PROJECT SOURCE NAME:CITRUS CO. CENTRAL LANDFILL (MOD)

Your application for a permit remains incomplete. Please provide the information listed below promptly. Evaluation of your proposed project will be delayed until all requested information has been received.

The purpose of this correspondence is to provide the additional requests in your letter dated November 20, 1995 to renew the Phase 1 operating permit for the Citrus County Central Landfill. Your requests for additional information are restated below with our response.

**FIGURE 1**  
0.5 - Year Interval Filling Plan

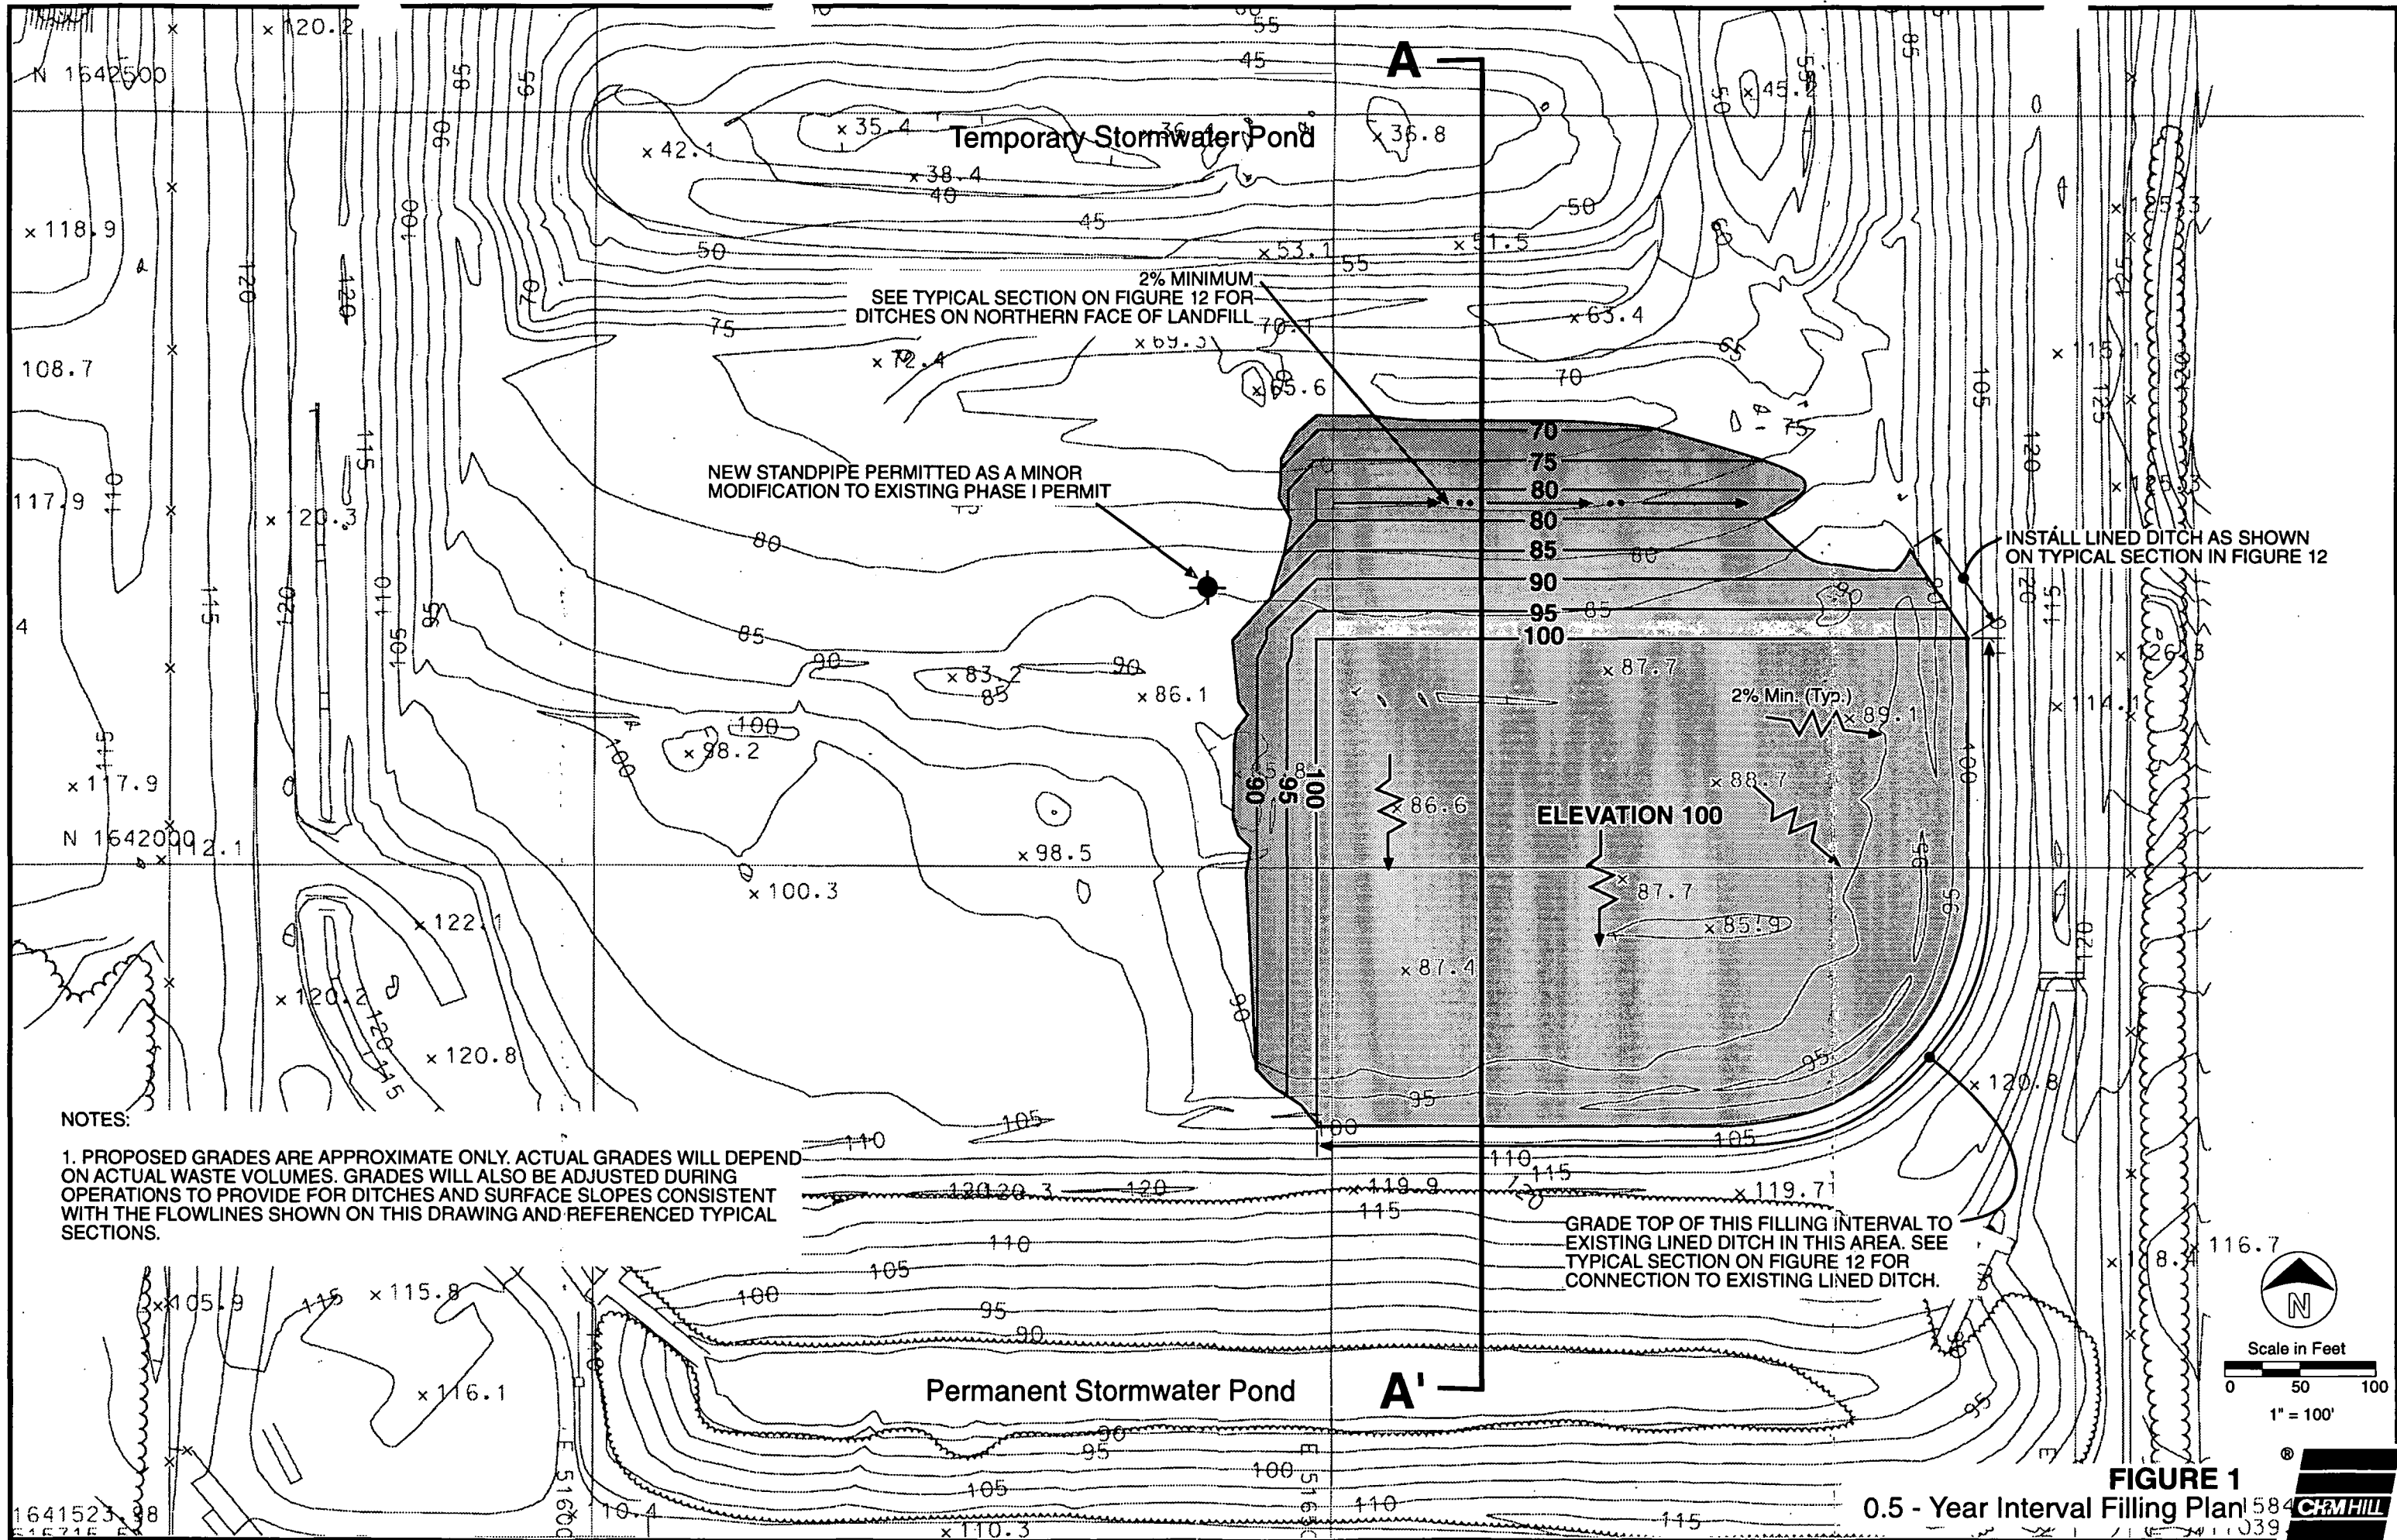
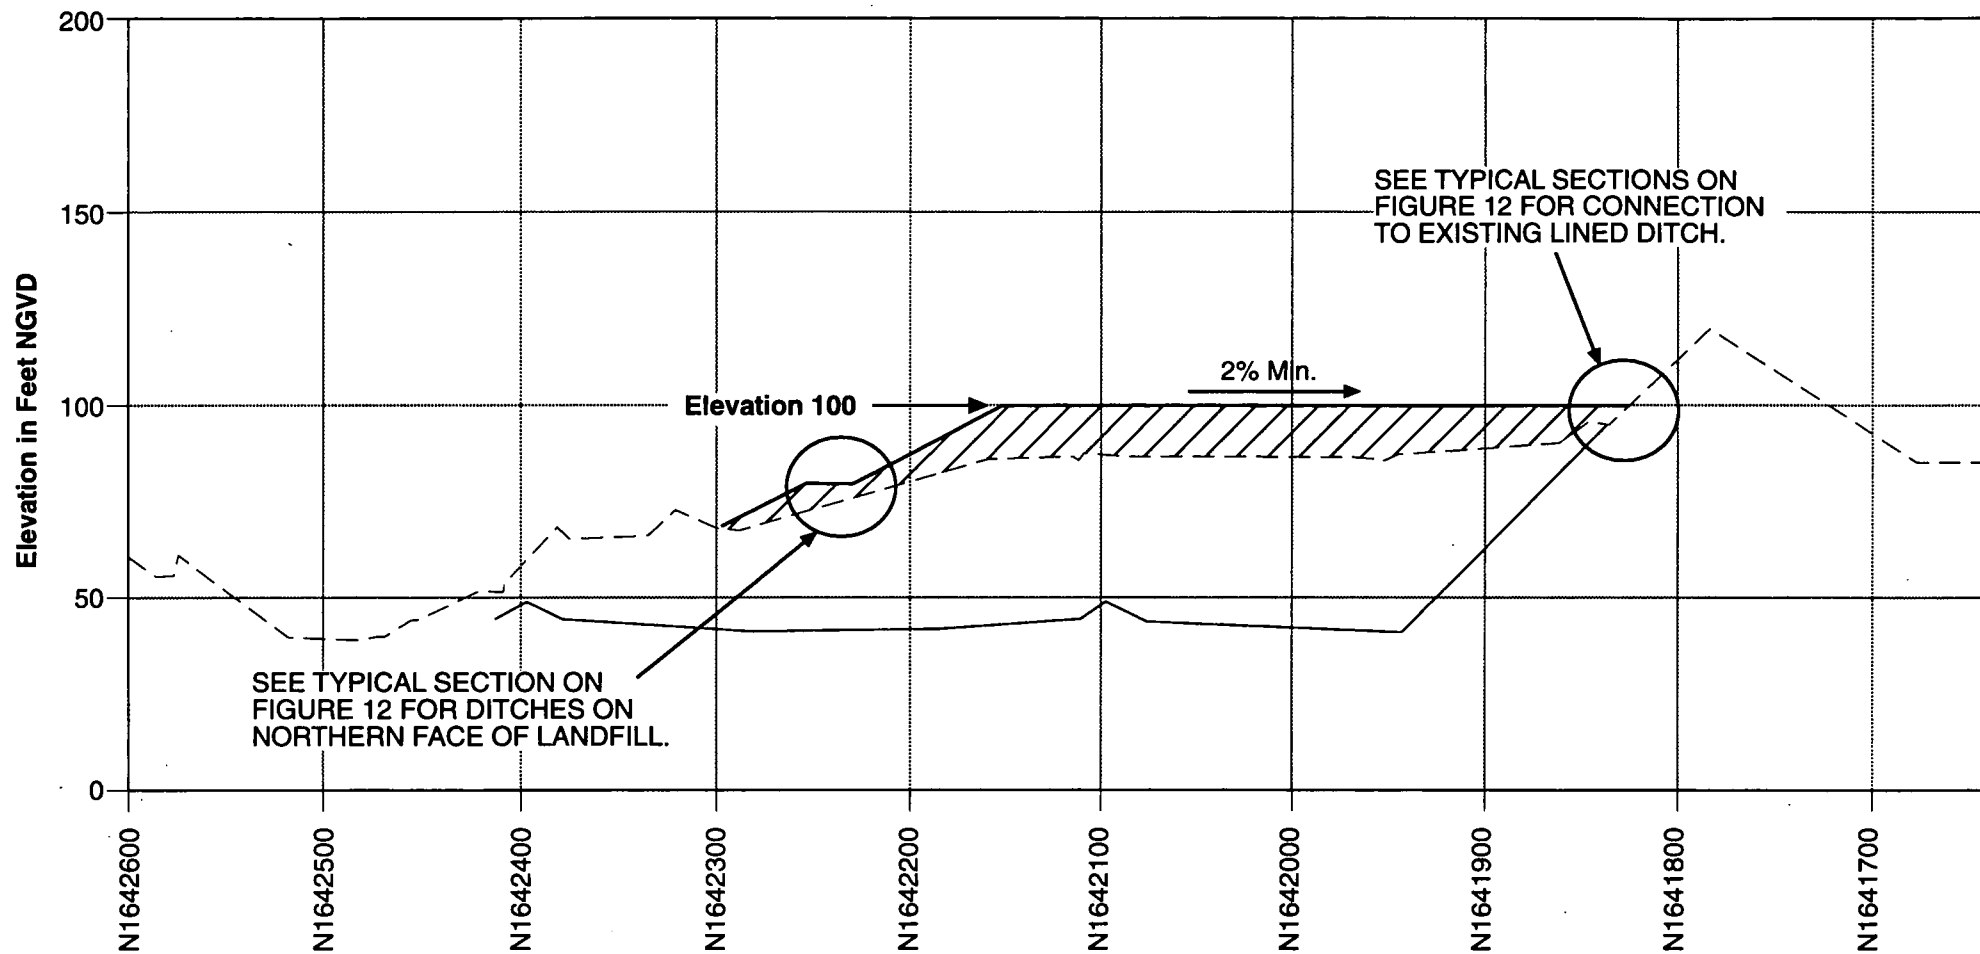
1. Revised drawings for sequence of filling and access roads across previously filled areas which show top slopes that promote drainage and allow runoff to enter existing and proposed stormwater conveyances, including:
  - a. revised cross-sections drawn to scale which show the proposed 2% minimum top slope (and note for % maximum top slope), with elevations of the top slope at each cross-section where connections are made to existing or proposed ditches; and

*Request No. 1 Revised drawings for sequence of filling with access roads across previously filled areas which show top and side slopes that promote drainage and allow runoff to enter existing and proposed stormwater conveyances.*

**Response No. 1** Revised drawings for sequence of filling are provided in Attachment A.

**DITCHES ON NORTHERN FACE**  
NOT TO SCALE

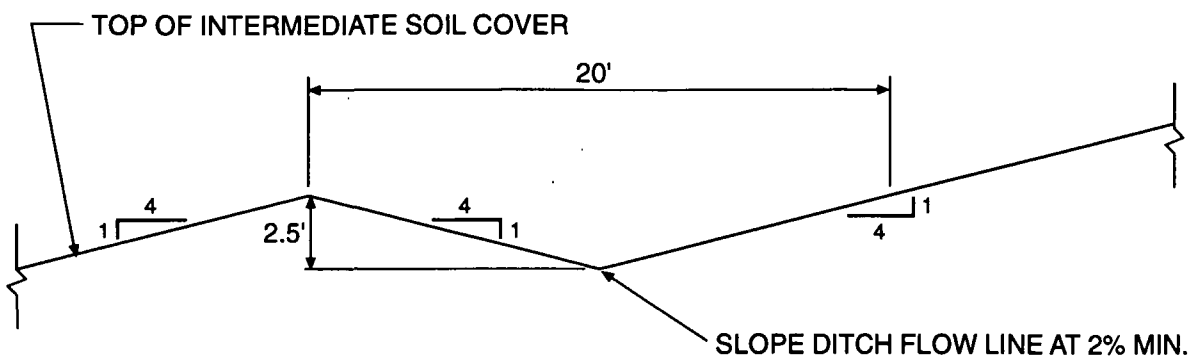
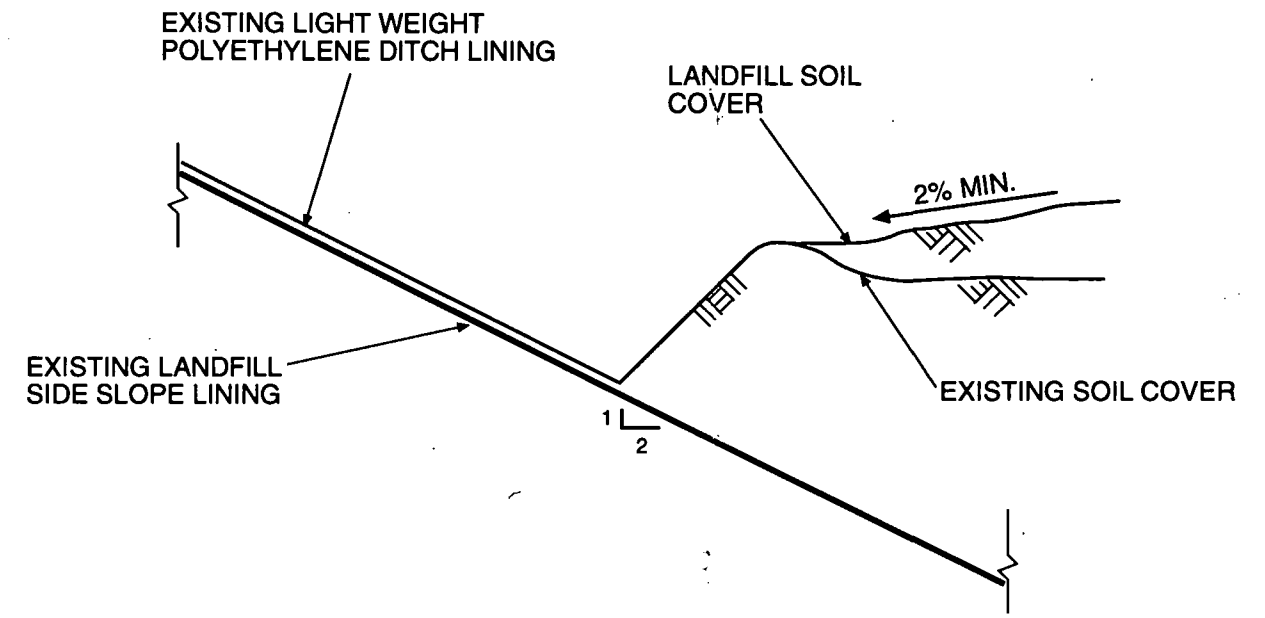
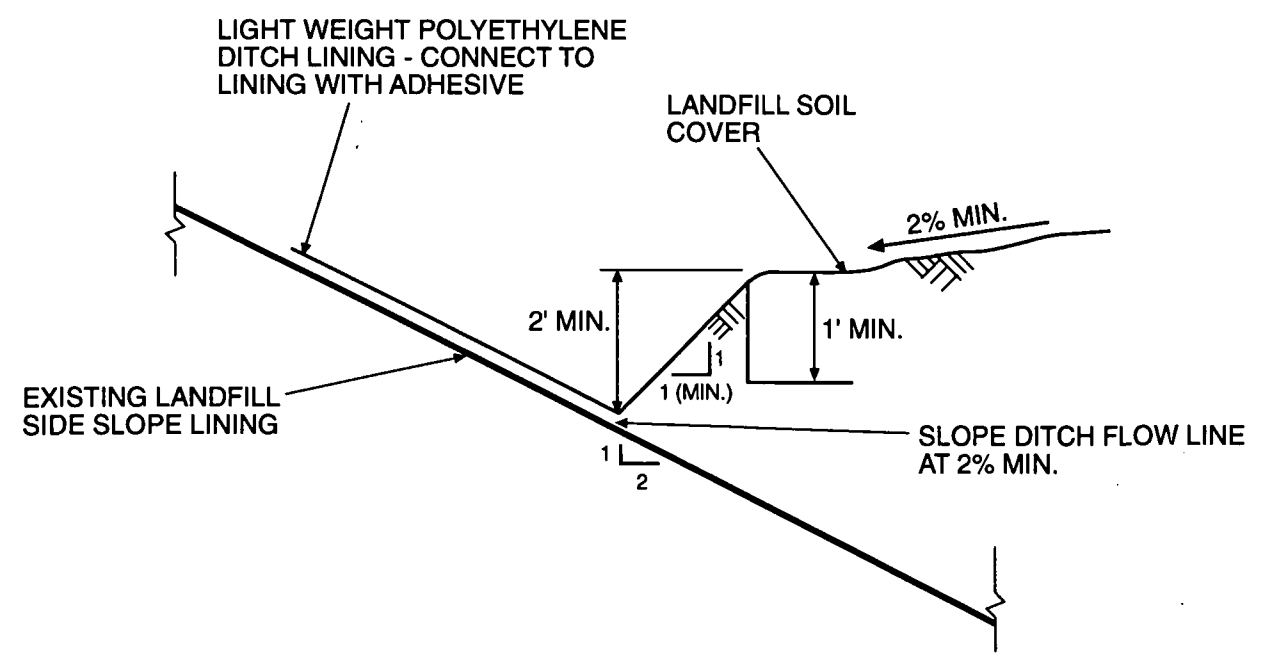
- c. revised typical sections for each type of temporary and permanent, existing and proposed stormwater conveyances for above and below grade filling with the same level of detail and construction notes requested in 1.b.

***Request No. 5*** Typical construction details for each type of temporary and permanent storm water conveyance for above and below grade filling or a specific reference for each detail previously submitted.

**Response No. 5** Typical sections are included on Figure 12 in Attachment A.

FIGURE 2  
Gas Probe Construction Detail

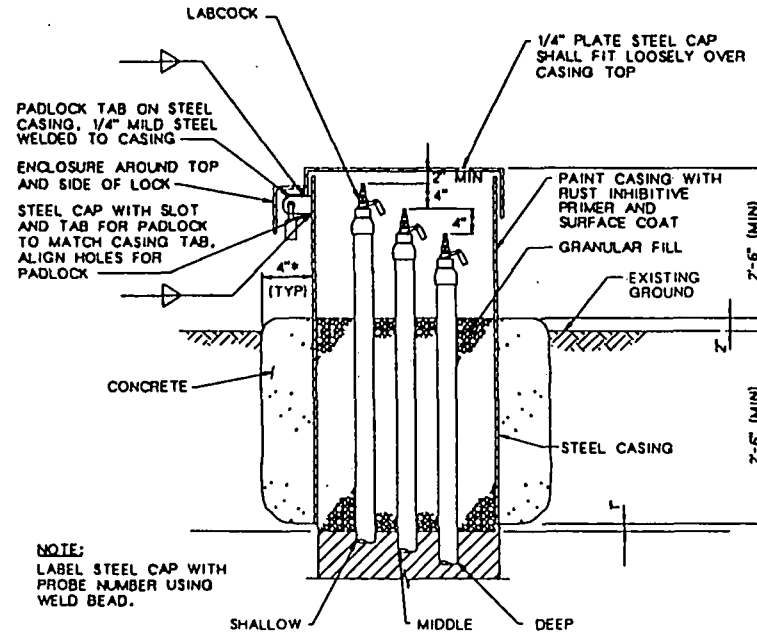
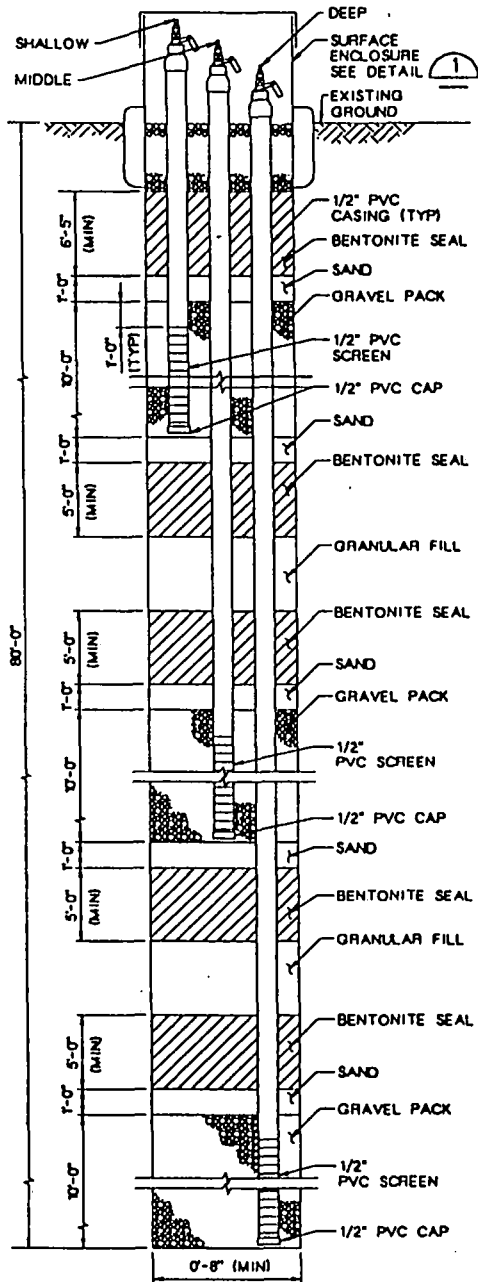
- c. the fourth paragraph, second sentence on page 3 of Attachment C which reads in part "The is to first attach the hose..."
- d. the need for two bentonite seals between each gas monitoring zone as shown on Figure 2 of Attachment C,
- e. the method of "continuous monitoring" proposed in the last paragraph on page 5 of Attachment C.
